MCHH-Ø25/Ø40 Profile Change Notification

MCHH-Ø25/Ø40 pneumatic grippers will have following changes.

Changed contents

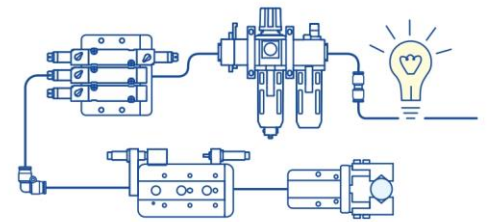
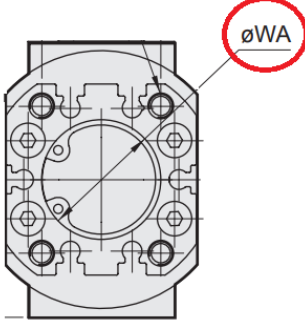
Before	After
Sensor		
	PS sensor	RDFE sensor
Bottom Installation Dimension		
	MCHH-Ø25 : diameter 26 height 2 MCHH-Ø40 : diameter 42 height 2	MCHH-Ø25 : diameter 26 depth 1.5 MCHH-Ø40 : diameter 42 depth 2
